Village of Royal Palm Beach
Village Council
Agenda Item Summary

PUBLIC HEARING TO CONSIDER APPLICATION 20-42 (LW), AN APPLICATION BY COTLEUR & HEARING, INC., AND ADOPTION OF LANDSCAPE WAIVER NO. 20-02 CONFIRMING COUNCIL ACTION. THE APPLICANT IS SEEKING WAIVERS FROM THE VILLAGE’S LANDSCAPE CODE AT SECTION 15-133 VEHICLE USE AREAS; PARKING LOT DIVIDER STRIPS AND ISLANDS; SECTION 15-131 PERIMETER LANDSCAPE BUFFERS REQUIRED; AND SECTION 15-143 PLANT MATERIAL STANDARDS; FOR A 14.22± ACRE PARCEL OF LAND LOCATED AT 10701 OKEECHOBEE BOULEVARD; BY AGENT: DONALDSON HEARING, OF COTLEUR & HEARING, INC.

**Attachment A
Landscape Plan
First Baptist Church (Connect Church)
20-42 (LW)
Landscape Waiver No. 20-02**

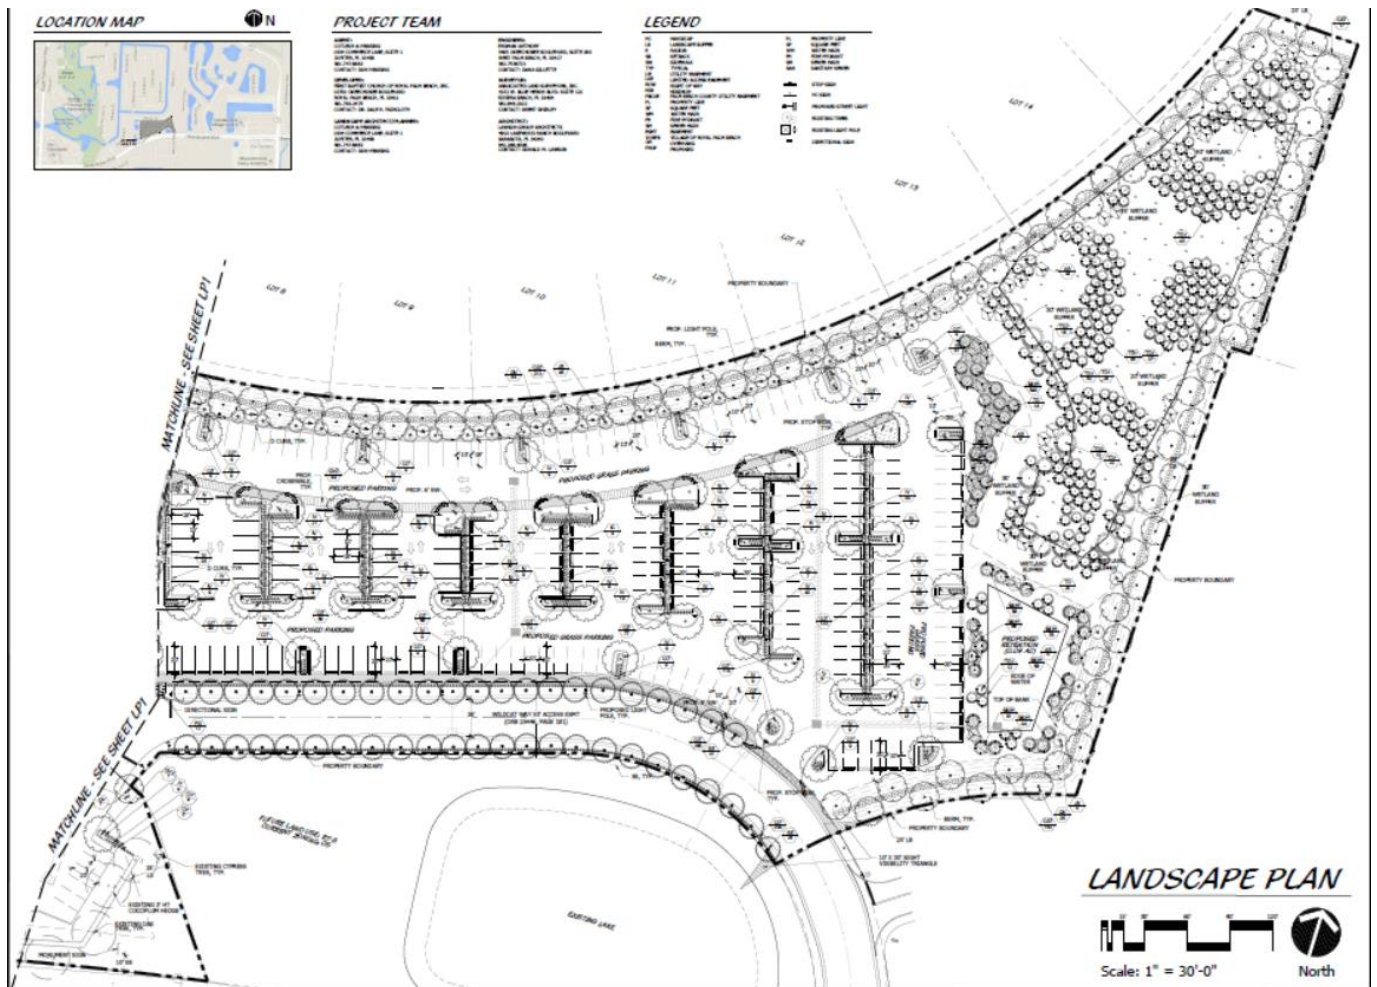
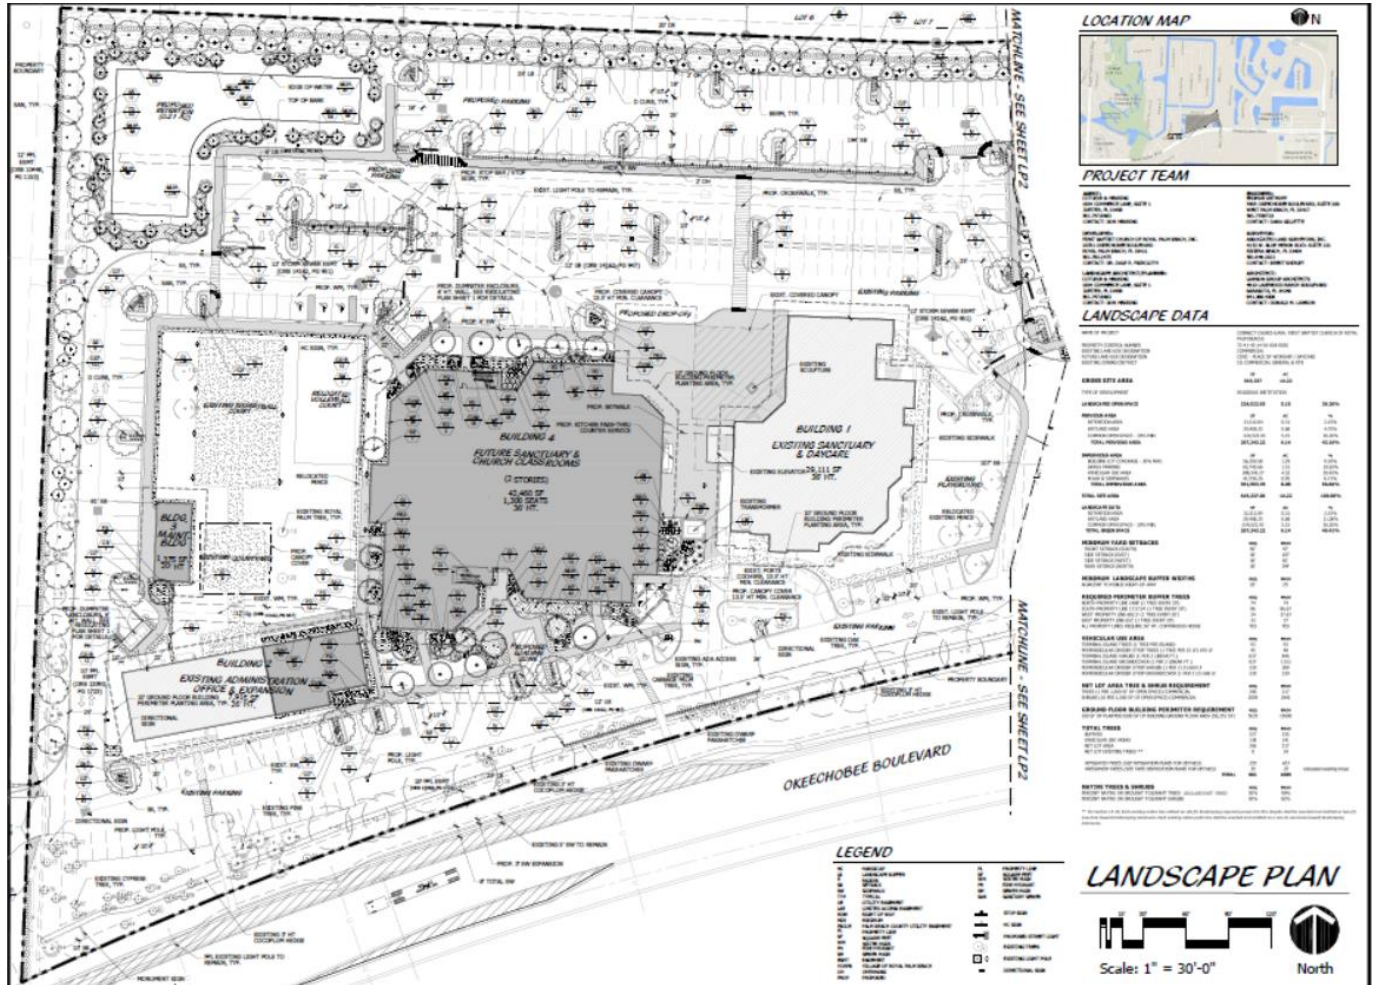
- Section 15-131 (c) *Buffering of nonresidential uses adjacent to a roadway.*
 1. Waiver #9: Along the south property line the Applicant is requesting the elimination of the three foot (3) berm requirement.
 2. Waiver #9: Along the south property line the Applicant is requesting a reduction of the required 25 foot buffer along Wildcat Way to 10 feet and tapering down to eight (8) feet.

1. Waiver #10: Along the North/East property line the Applicant is requesting to eliminate the berm requirement.

2. Waiver #11: Along the West property line the Applicant is requesting to eliminate the berm requirement.

1. Waiver #1: To the north of the existing church building the Applicant is requesting a reduced width for a perpendicular landscape divider strip. The Applicant is proposing to reduce the required five (5) foot perpendicular landscape strip down to 3.5 feet wide.

2. Waiver #8: Directly to the north and east of the church building the Applicant is requesting a reduced width for a perpendicular landscape strip.

- Section 15-133 (e) *Double terminal islands*: In various areas of the Landscape Plan the Applicant is requesting a reduction in the required minimum eight (8) foot wide double terminal island down to seven (7) feet for five (5) double terminal islands and down to six (6) feet for one (1) double terminal island (Waiver #2-7).

- Section 15-143 (c) *Trees*: This waiver request (Waiver #12) is to allow for a reduction in the plant material standards for the required Village Code mitigation trees for the project. Village Code requires that upon planting of mitigation trees, they have a height of 14 feet with a diameter at breast height of 2.5 inches.

- Section 15-133 (d) *Palms*: This waiver request (Waiver #13) is to allow Royal Palm trees to be counted at a one (1) palm tree to one (1) shade tree ratio, for the required shade trees; where Village Code requires palm trees to be counted on a three (3) palm trees to one (1) shade tree ratio.

- Section 15-133 (c) *Parallel divider strips*: This waiver request (Waiver #14) is to allow a row of 16 parking spaces without a landscape island to break them up. Village Code requires a landscape parallel divider strip every ten (10) parking spaces.

Staff is recommending **Approval** of this request and generally agrees with the Applicant’s justification of the waiver request.

Staff is recommending **Approval** of this request and generally agrees with the Applicant's justification of the waiver request.

Staff is recommending **Approval** of this request and generally agrees with the Applicant's justification of the waiver request.

Staff is recommending **Approval** of this request and generally agrees with the Applicant's justification of the waiver request.

Staff is recommending **Approval** of this request and generally agrees with the

Staff is recommending **Approval** of this request since the deficiency is due to the use of sidewalks which promote safe pedestrian circulation within the site; and the deficiency is offset with the much larger widths provided on the other side of the double terminal island.

Staff is recommending **Denial** of this request because there are no site constraints

Staff is recommending **Approval** of this request to allow Royal Palms to be counted at a one (1) palm tree to one (1) shade tree ratio since this request has been approved for a number of other projects within the Village and these types of palms at maturity will achieve the minimum of 15 foot in height and a 15 foot spread requirement for mature canopy trees.

Staff is recommending **Approval** of this request since this is an existing condition.
